From: [REDACTED]
To: [A303 Stonehenge](#)
Cc: [REDACTED]
Subject: FW: Blick Mead submission
Date: 03 May 2019 17:20:44
Attachments: [CHRONOLOGY OF EVENTS CONCERNING PROPOSED MONITOING OF LOCAL WATER TABLE AT BLICK MEAD.docx](#)
[mrrb 02-05-2019 14-23-10.pdf](#)
[Prof David Jacques statement re meeting of 6.12.18.msg](#)
[Statement 17042019.docx](#)
[Blick Mead significance submission by Prof Jacques.docx](#)
[Stonehenge - Prof Brown Professional Assessment of the A303 Amesbury to Berwick Down TR010025 \(003\)-2.docx](#)
[FW Written Questions from the Examining Authority.msg](#)
Importance: High

On behalf of the Consortium of Archaeologists and the Blick Mead Project, I am submitting this written representation on the specific issue of the significance of the Blick Mead site and the risk that it might be damaged or even entirely sterilised by the proposed infrastructure of the proposed tunnel scheme. This is one of the issues we identified in our relevant representation of 11.1.19 and in response to the Rule 6 letter inviting us to make representations at the preliminary meeting of 2.4.19.

Author	Client	Scale	Date
Drawn	Checked	Approved	Issue
DRAFT			
HIGHWAYS ENGLAND			
A303 STON

Figure 1: Highways England Monitoring points: location plan in relation to previous investigations at Blick Mead.

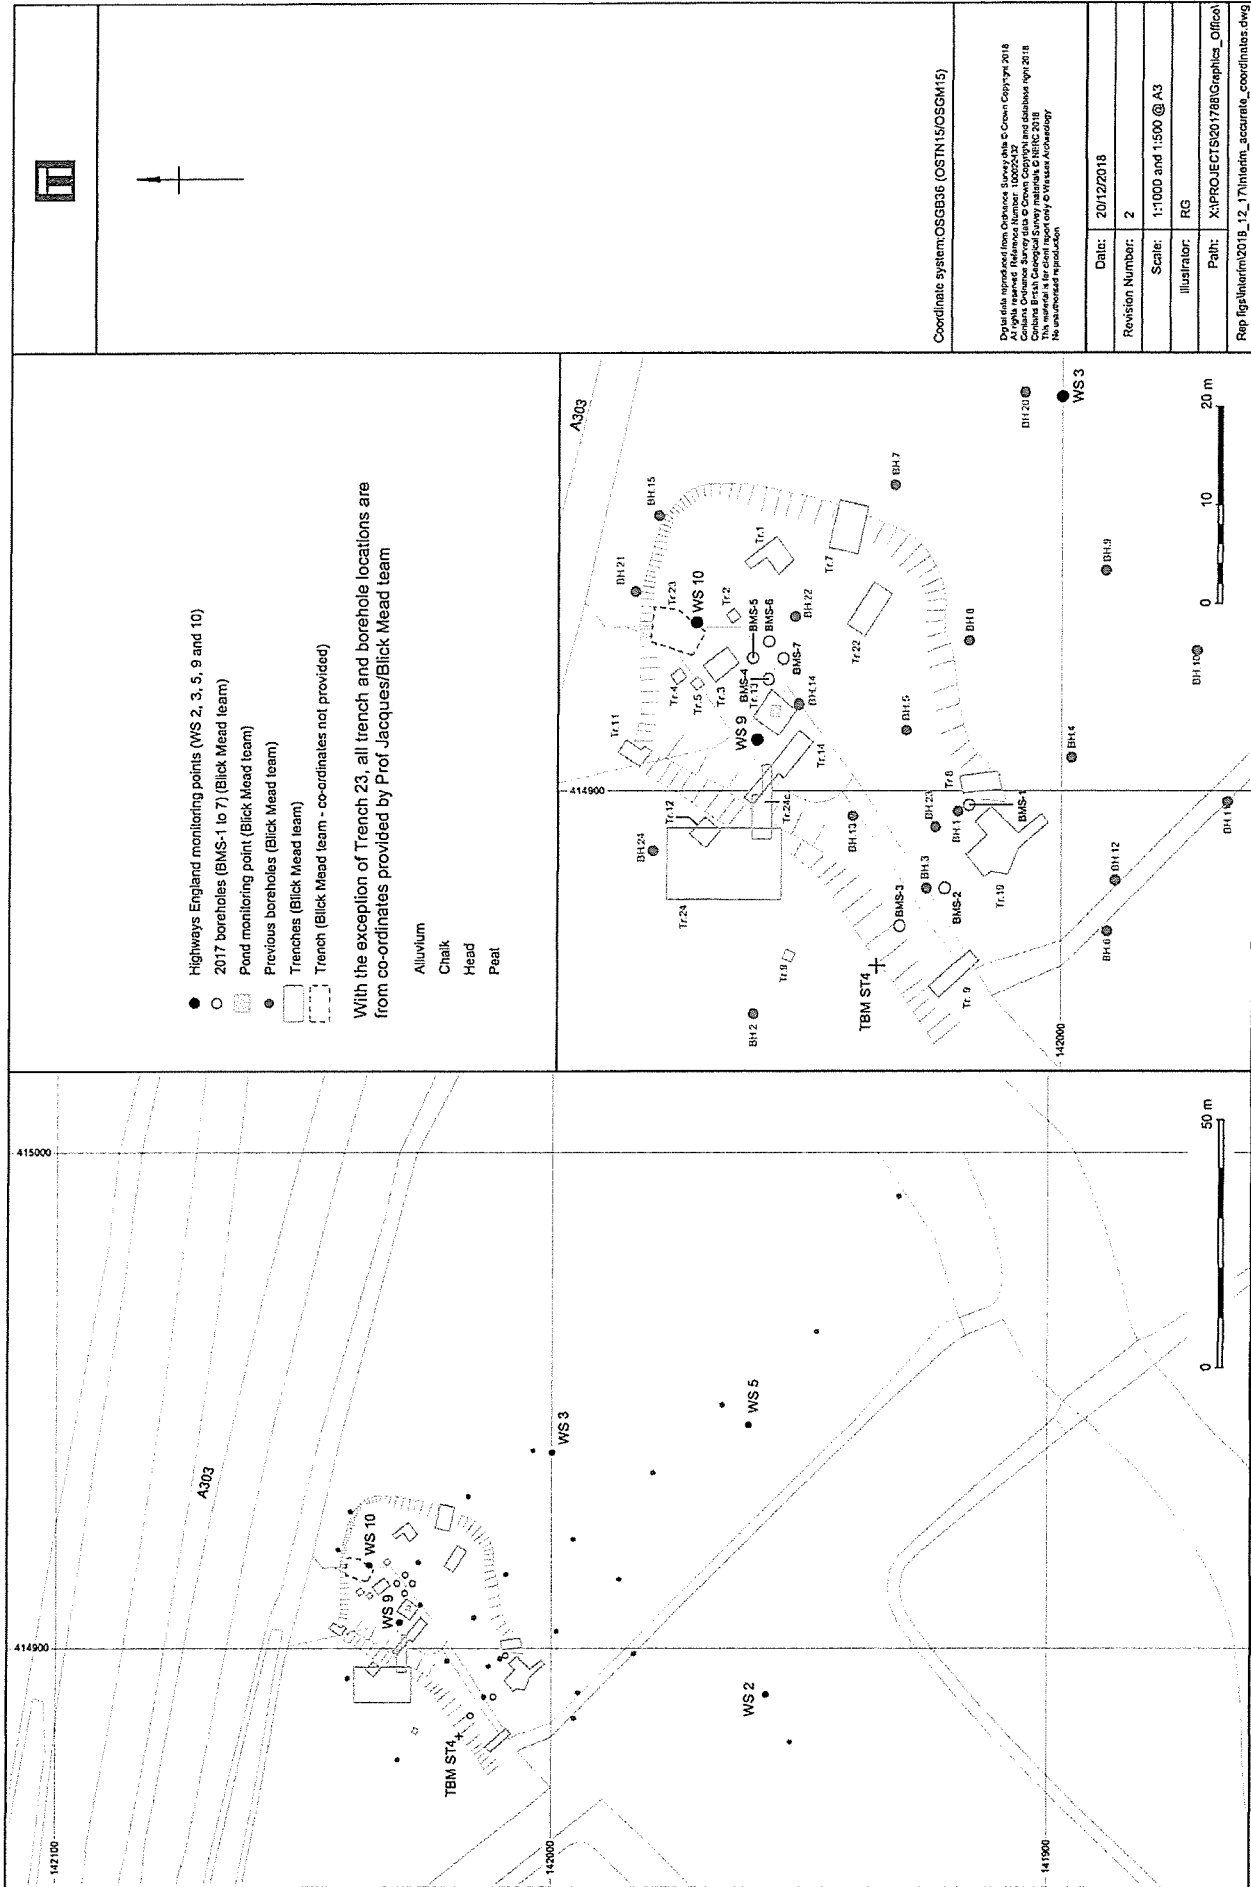
From what I am being told some of the equipment has been put on the terrace facing the Blick Mead spring where the late Mesolithic occupation area is. This area has dense spreads of Mesolithic archaeology - the only place in the WHS that has it - and we are really concerned that it will be damaged by your team digging holes through it. I am also concerned that some of your other stations are going to be in the wrong places and that there is insufficient coverage in the spring. Please see Professor Tony Brown's comments to me below (p12) about this. The figure he mentions in your report is not detailed enough to use as a guide for placing water table probes. And I have raised this before. TB also lists other inadequacies in the Highways Report in relation to Blick Mead

Both of these measurements are over what was recommended by Professor Tony Brown in our meeting in London on April 16th (and repeated in his email today below). We are still to receive minutes from from the meeting 7 months later, but his comment should be in them. Why wasn't his recommendation about dipwells and 2-5cm diameter points taken up? Why wasn't I informed that the installations would be this size? This should have been agreed beforehand. Had this be done the damage to this part of the site would have been mitigated.
